TOWN OF SHERBORN
19 Washington Street
Sherborn, MA 01770

**RE: Proposed 40B—Washington Street Sherborn Homes
Sherborn, MA
MH ID No. 1260**

Subject: Comments for the SB and MassHousing on the proposed 40B 4-unit Washington Street Homes.

RE: Comments on Washington Street Sherborn Homes – 40B Project Eligibility and
Public Health Concerns

Reference Map 2

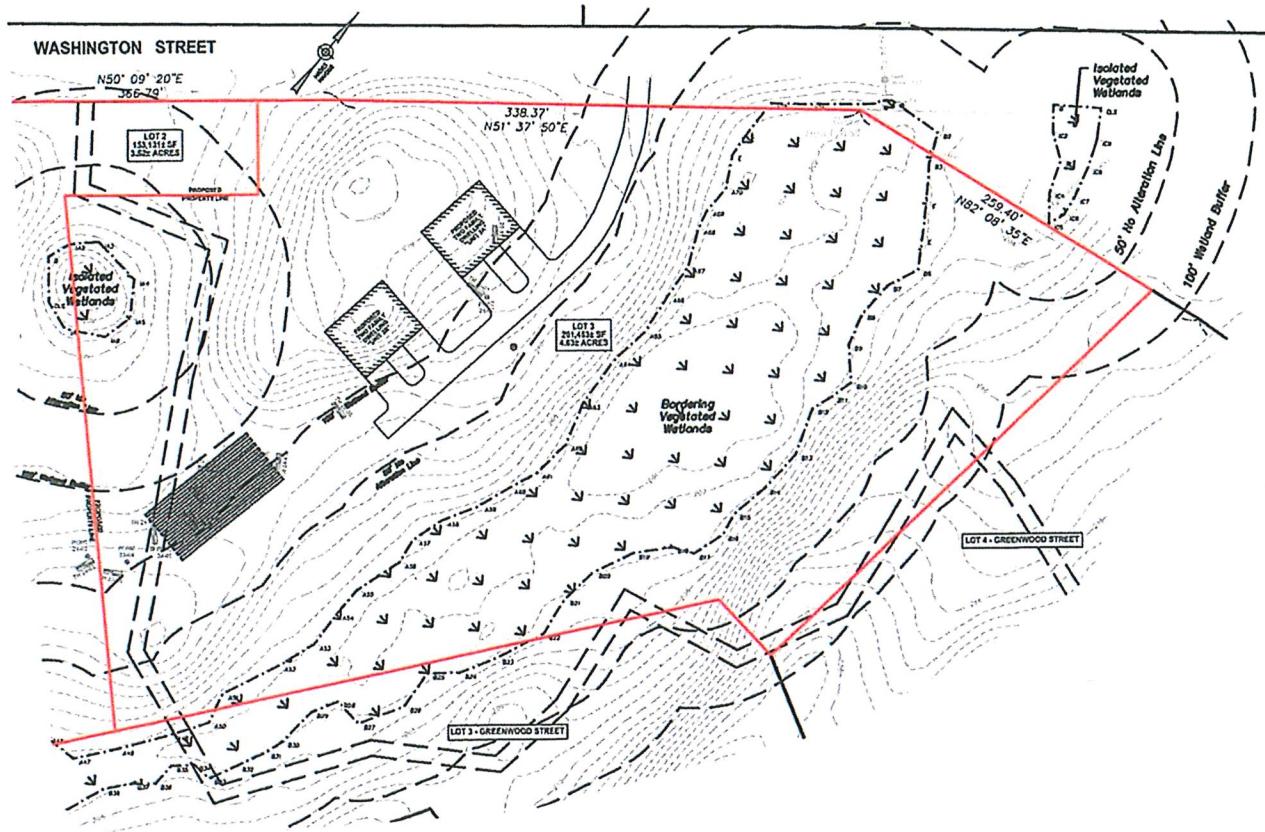
Design and layout. The preliminary layout plans show a proposed 2-building footprint whose placement is constrained by wetlands that cross the parcel. The building design is generally compatible with homes in Sherborn and the region.

Environmental impacts. The project site has extensive natural wetlands connected to a wetland resource area on an adjacent property. It is critical to maintain wetland resources to ensure

protection of private and public water supplies of the entire area, as well as stormwater management and wildlife habitat support. A specific concern is that the project as proposed involves disturbance of some wetland buffer zone areas.

Energy use and sustainability. The Applicant is applauded for the goal of a net-zero energy goal with carbon-neutral features including energy conservation measures and solar panels. The plan does not show proposed locations of solar installations. It will be important to maximize use of rooftops and paved parking areas for solar arrays. Any ground-mounted solar panels must be placed in locations that preserve the existing tree cover.

Pedestrian and Bicycle Safety - There are currently no safe pedestrian or bicycle routes in or out of the project site, other than a rocky hiking trail along an easement to Greenwood Street. The applicant is committed to maintaining the trail easement across the property. It is understood that the exact location may be altered, but the easement must continue to provide a pleasant and safe route for pedestrians and residents.

Figure 1:

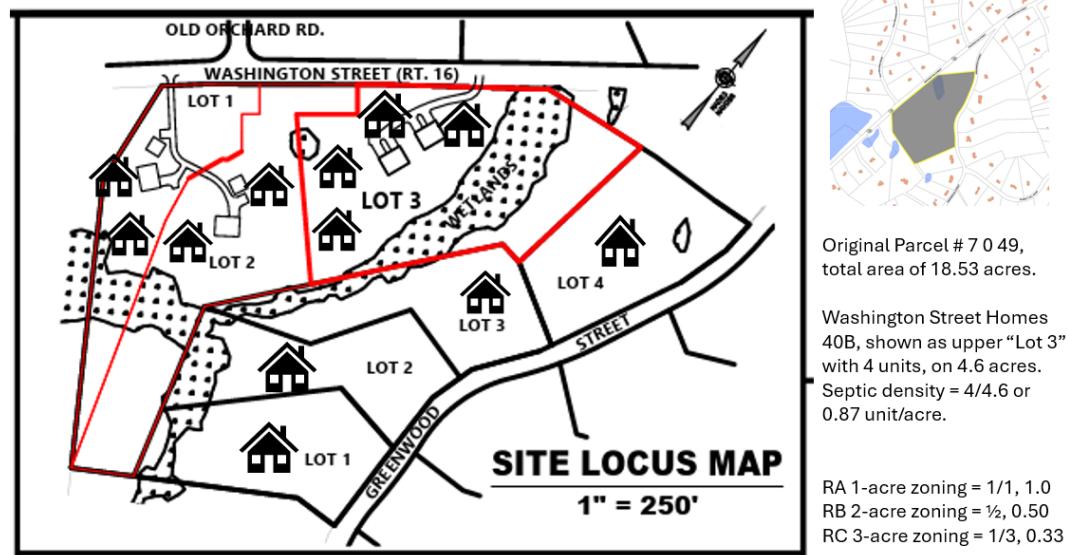
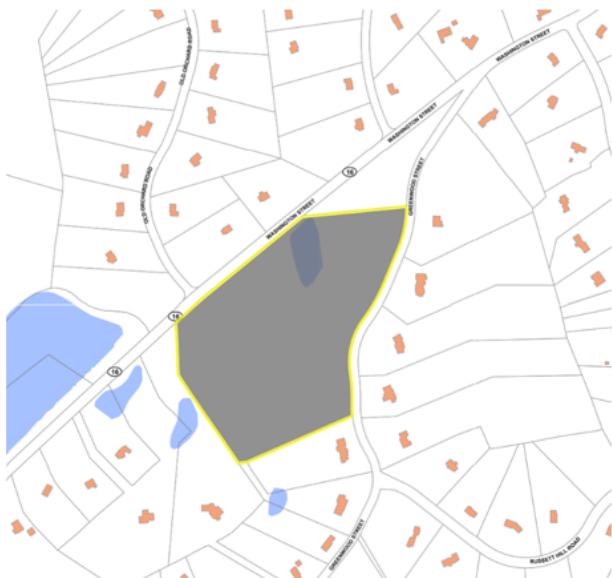
The current 40B proposal is to be developed on a 4.6-acre parcel, that was originally part of a larger 18.53-acre lot. Presented here are two maps (Figures 1 and 2) that indicate the septic densities involved (now approved 6 lots, two with accessory dwelling units):

Original Parcel # 70 49, total area of 18.53 acres.

Total # of housing units now planned or approved for this total area: 12 units.

Resulting septic density of approx. $12/18.53 = 0.65$ unit/acre.

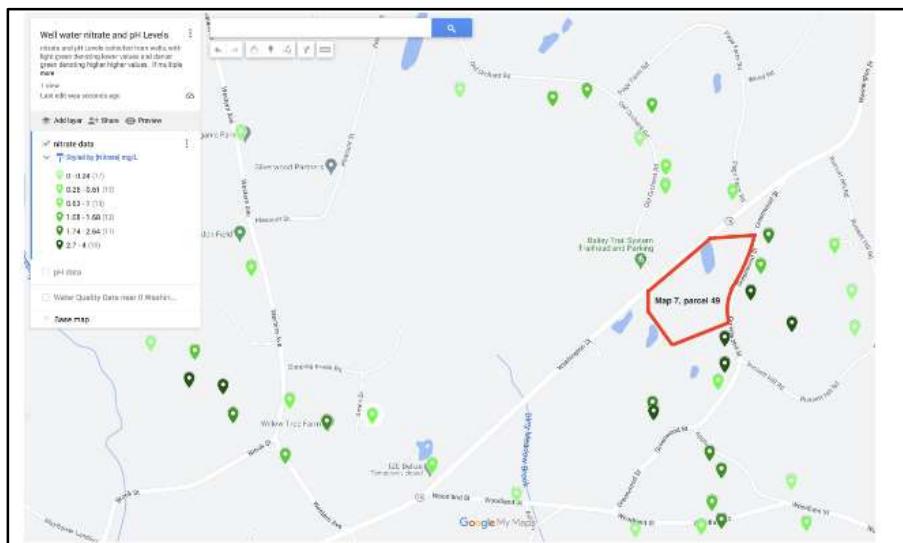
The study area is largely focused on the subdivision to the north of the site (encompassing Old Orchard Road, Page Farm Road, and Wood Road) and Greenwood Street towards Washington Street. As can be seen in the following graphical displays about nitrate levels in the wells of residences, there is a difference in nitrogen levels being detected in the drinking water for each of these areas, with the Greenwood Street area results being generally higher.

Figure 4: Historic, reported well water nitrate concentrations (mg/L) are plotted against test year for those properties mapped in Fig. 3. Data from selected properties on Greenwood St. are plotted in blue and described below, while data from all other properties are plotted in green.

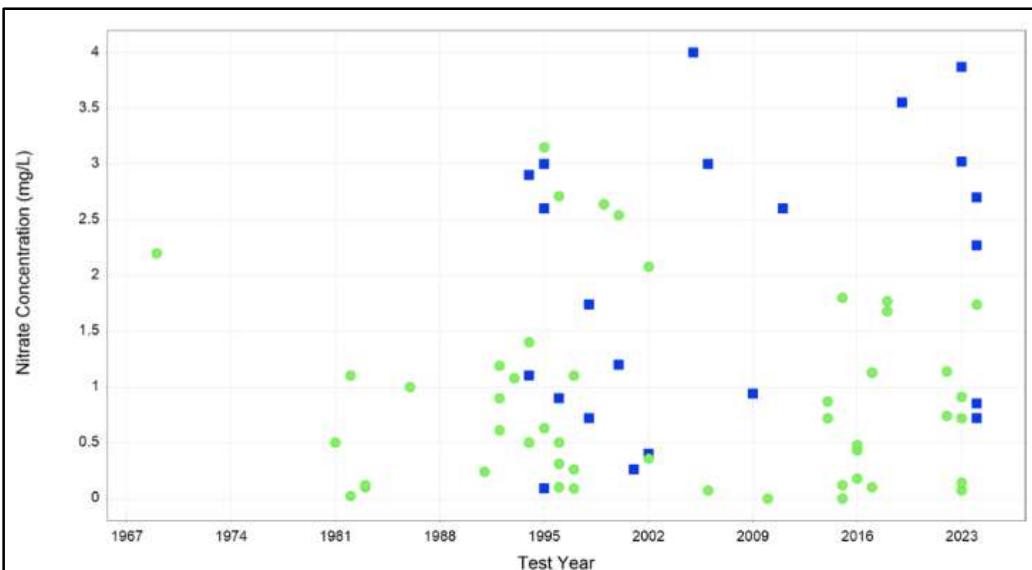
Since the septic systems along Greenwood Street are newer, on average, than the subdivision to the north, one or both of the following conclusions are possible:

- ***Localized soil characteristics, depth to groundwater, presence of wetlands, and/or bedrock characteristics may be playing a role.*** In other words, the subsurface treatment dynamics closer to Greenwood Street might be less effective at removing nitrogen prior to the septic effluent reaching groundwater.
- More recent development on Greenwood Street means that well test results also tend to be more recent. Under this condition, ***the higher levels of nitrates being measured may be indicative of a trend of rising levels of cumulative septic impacts in the overall area.***
